GULF STATES UTILITIES COMPANY

February 5, 1985
RBG- 20,079
File No. G9.5, G9.19.2
G9.20.6

River Bend Station - Unit 1
Docket No. 50-458

The attached information is being provided as requested by the Nuclear Regulatory Commission's Emergency Preparedness Licensing Branch (EPLB) for it's review and input to Safety Evaluation Report Section 13.1.

EMERGENCY OPERATIONS
FACILITY-FLOOR PLAN

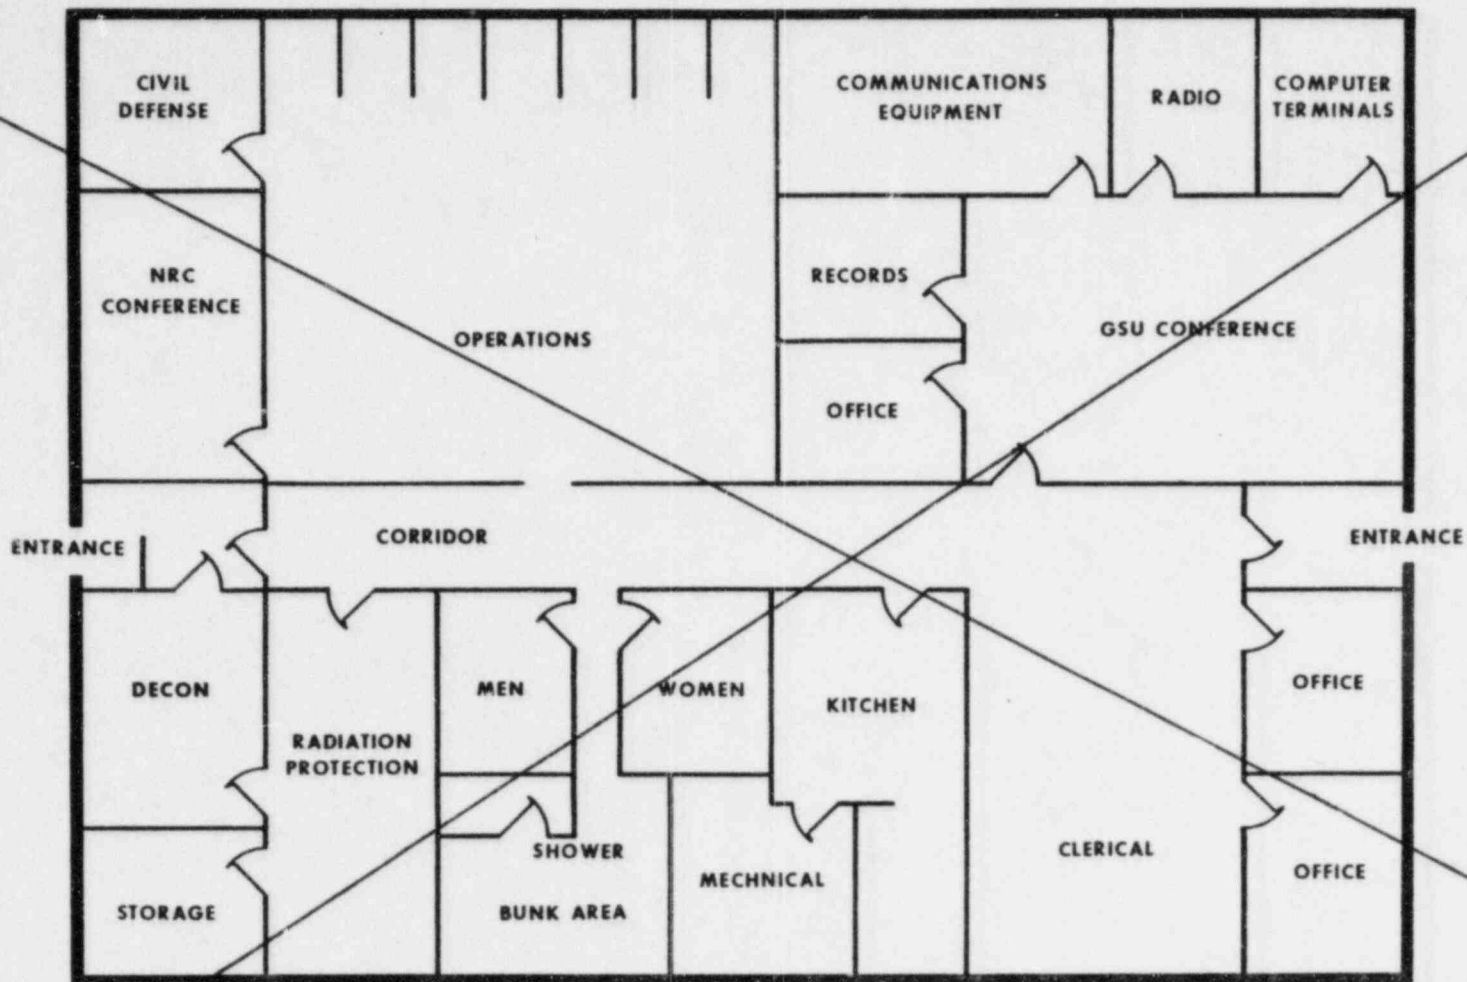
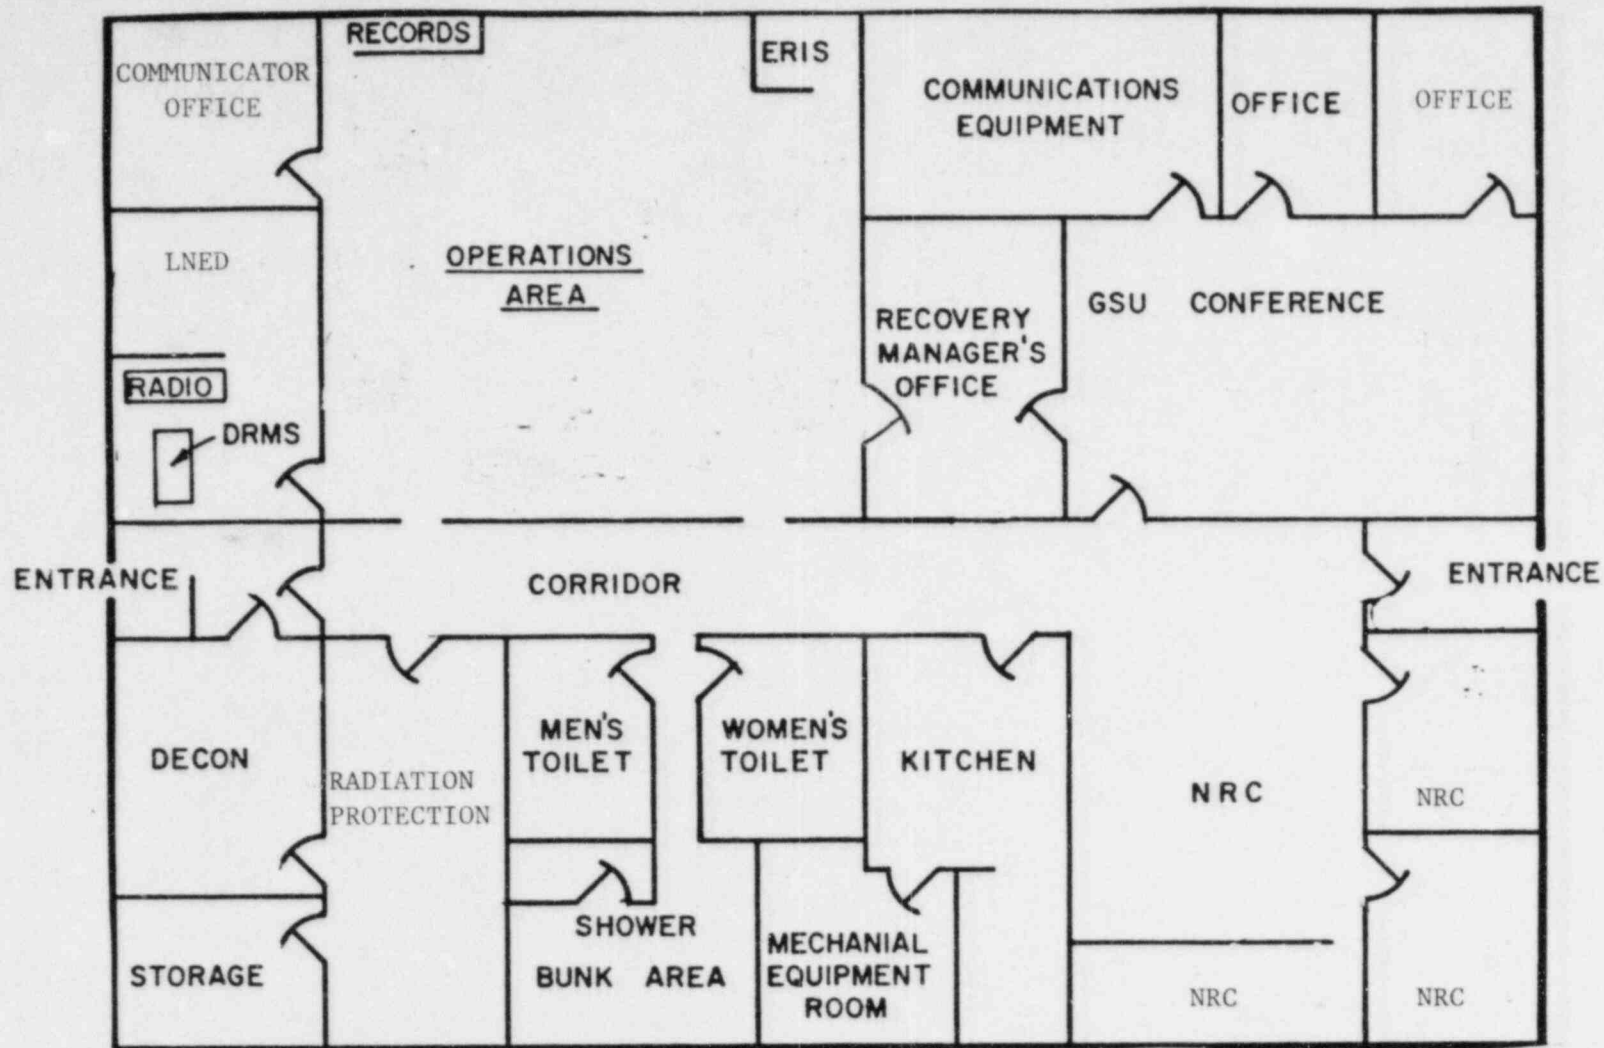
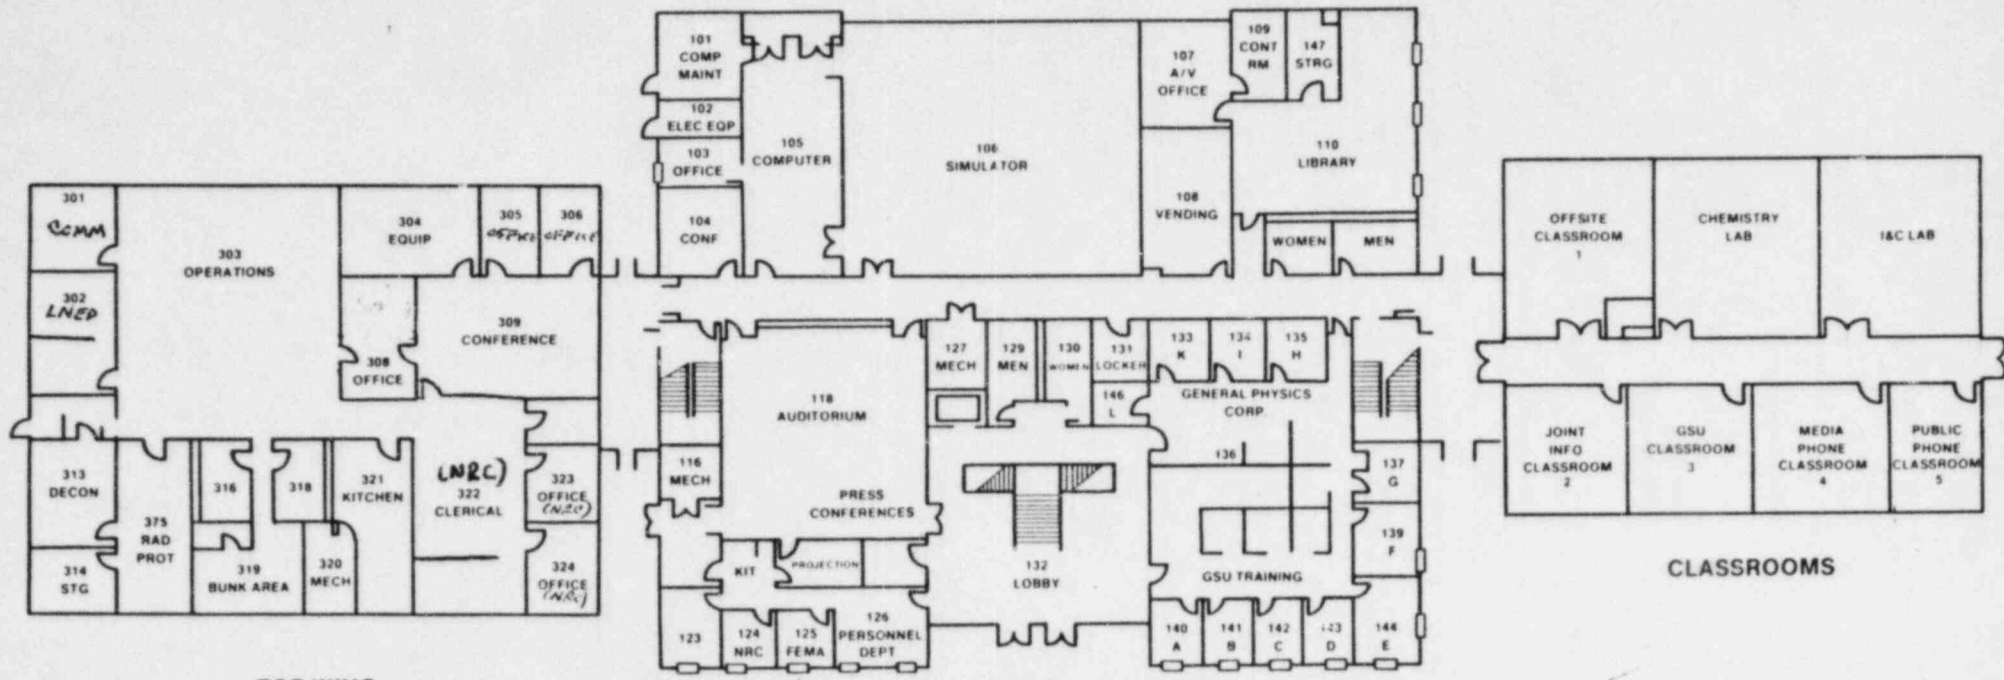
SEE NEW FIGURE 13.3-22 ATTACHED
